**Comanche Peak Nuclear Power Plant, Units 3 & 4
COL Application**

**Part 2, FSAR
Update Tracking Report**

Revision 2

Figure 2.5.4-245 Estimated Range of Rock Mass Modulus (E_{rm})

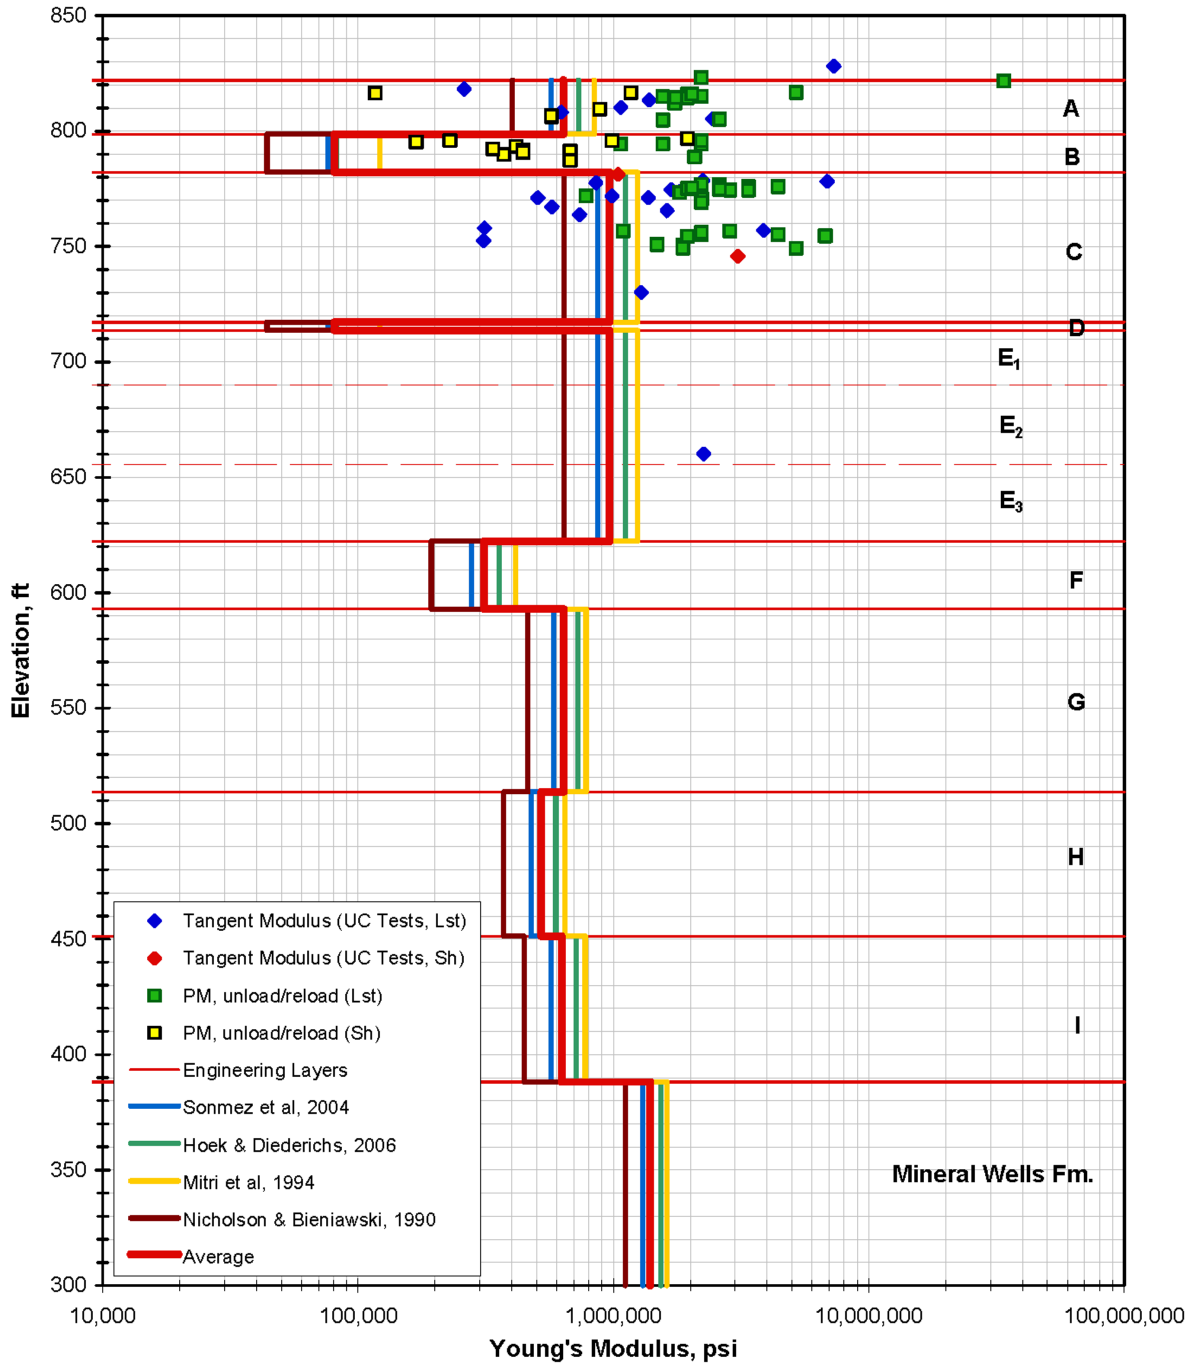
CTS-00554	List of Figures	2-I	Increase information as discussed with the NRC to summarize the reports provided in Luminant's letter TXNB-08027 to NRC dated November 4, 2008.	Added Figure 2.5.4-245	2
CTS-00703	Table 2.3-332	2.3-233 2.3-234	To reflect CPNPP Units 3 and 4 compliance with RG 1.23	Added "Second Proposed Revision, April 1986" to the footnotes	2
CTS-00554	2.5.4.10.1	2.5-189	Increase information as discussed with the NRC to summarize the reports provided in	Additional discussion and equations to reflect what calculations and analyses were performed to demonstrate bearing	2

CTS-00554	Tables 2.5-4-228 through 2.5.4-231	-	Increase information as discussed with the NRC to summarize the reports provided in Luminant's letter TXNB-08027 to NRC dated November 4, 2008.	Added new tables to reflect bearing capacity discussion and settlement discussion within subsections.	2
CTS-00554	Figure 2.5.4-245		Increase information as discussed with the NRC to summarize the reports provided in Luminant's letter TXNB-08027 to NRC dated November 4, 2008.	Added Figure 2.5.4-245.	2
